UNITED STATES PATENT AND TRADEMARK OFFICE

| APPLICATION NO. | FILING DATE | FIRST NAMED INVENTOR | ATTORNEY DOCKET NO. | CONFIRMATION NO. |
|-----------------|-------------|--------------------------|---------------------|------------------|
| 10/070,577 | 07/09/2002 | Jordi Galan I Llongueras | 8000-21 | 7171 |

Office Action Summary

DETAILED ACTION

FIG. 7

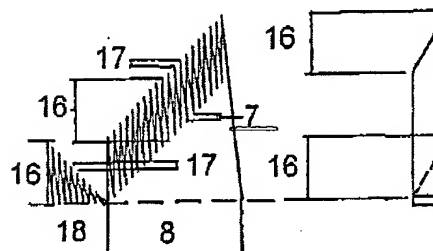
Figure 7 contains two separate figures, which should be identified as such in the Drawings and in the Specification.

Figures 6 and 7 contain foreign language.

Figure 7, detail "7" shown below should read --17--.

FIG. 6

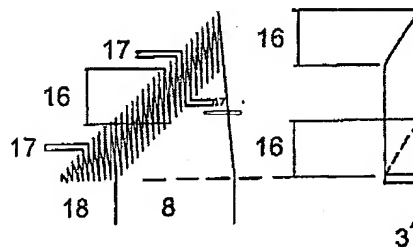
Figure 6 contains two separate figures, which should be identified as such in the Drawings and in the Specification.

Figure 6, detail "17" shown below should be the same font so as to be visible.
